SRRTEP Committee: Mid-Atlantic PSE&G Supplemental Projects

January 18, 2024

Cost Update for s2318

Update to Solution for s2318

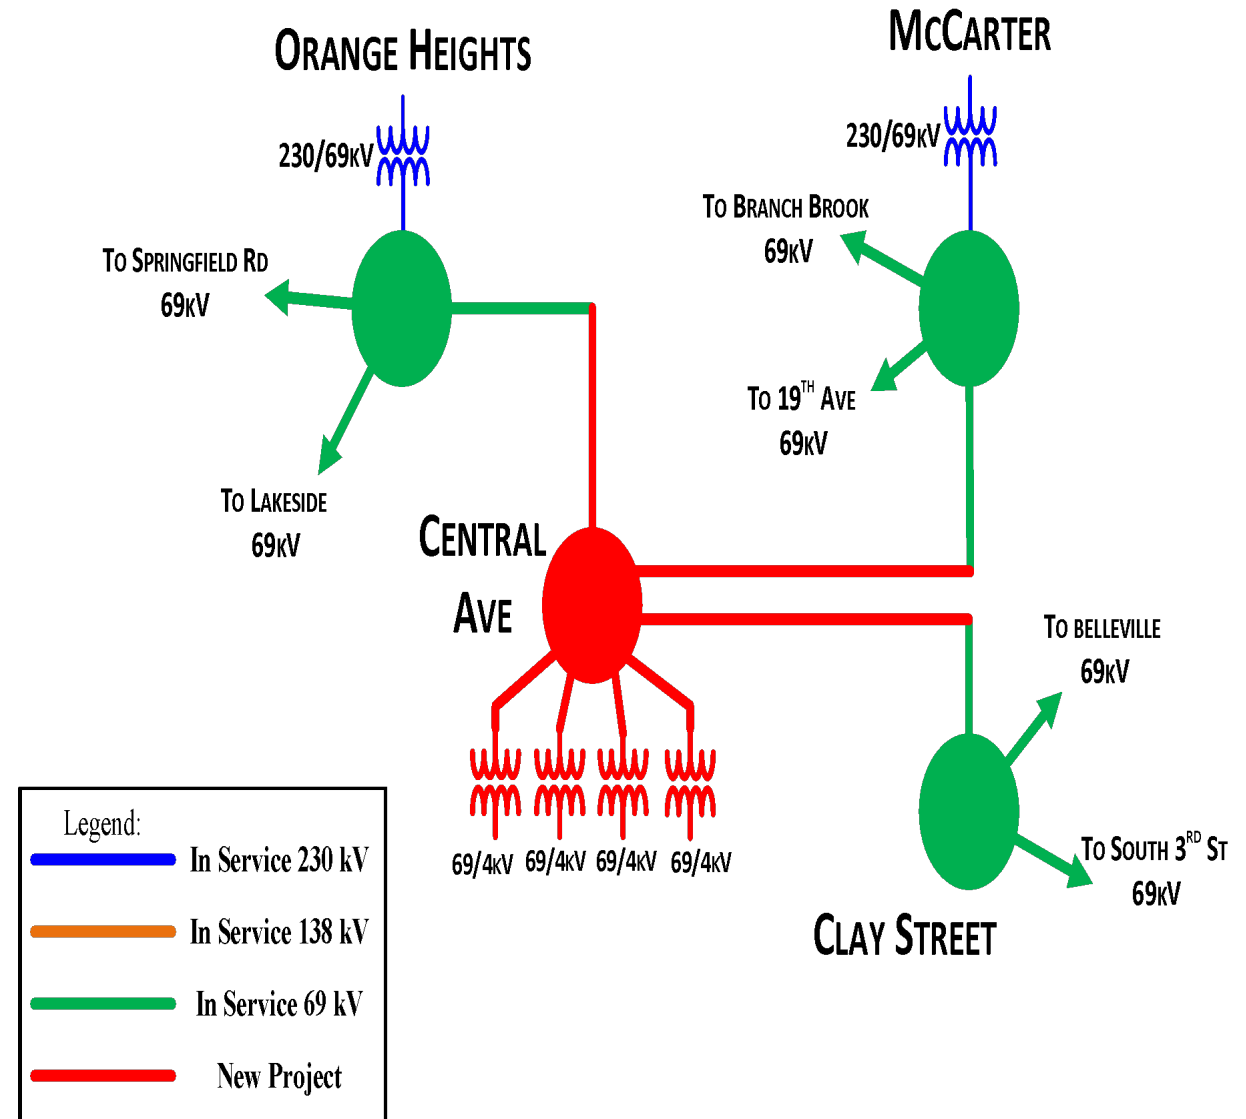
- **Estimated Cost:** ~~\$34.3M~~ \$85.2M
- **Projected In-Service:** ~~05/2024~~ 12/2026

- Updated Solution:

- Purchase property directly adjacent to existing Central Ave substation.
- Same electrical scope as previously selected solution.

- Reasons for Updated Solution:

- Property originally identified by PSE&G to build an Air Insulated Switchgear (“AIS”) station.
- PSE&G was aware that the property was part of a redevelopment plan that includes an affordable housing requirement, but pursued the property with the intention of working with the City of Newark to modify the redevelopment plan so that an AIS station could be constructed.

- The City was ultimately not willing to remove the affordable housing component of the redevelopment plan, thereby reducing the available space to construct an AIS station.

- PSE&G cannot consider Original Alternative 1 on the prior slide because it also involves building AIS on the property originally identified by PSE&G.

- A GIS station could only be constructed on the original property if additional property is purchased, but the total estimated cost of the project would be approximately \$100M. This increased cost and inability to change the redevelopment plan led PSE&G to explore additional alternatives.

- PSE&G is able to acquire new property directly adjacent to PSE&G’s existing Central Ave station, which was not previously available and does not have redevelopment plan restrictions.

- Updated estimated cost reflects new property purchase and GIS construction.
- Updated projected in-service date reflects GIS equipment lead time, time required to pursue new property, redesign from AIS to GIS, and additional time for obtaining site plan approvals from the City.
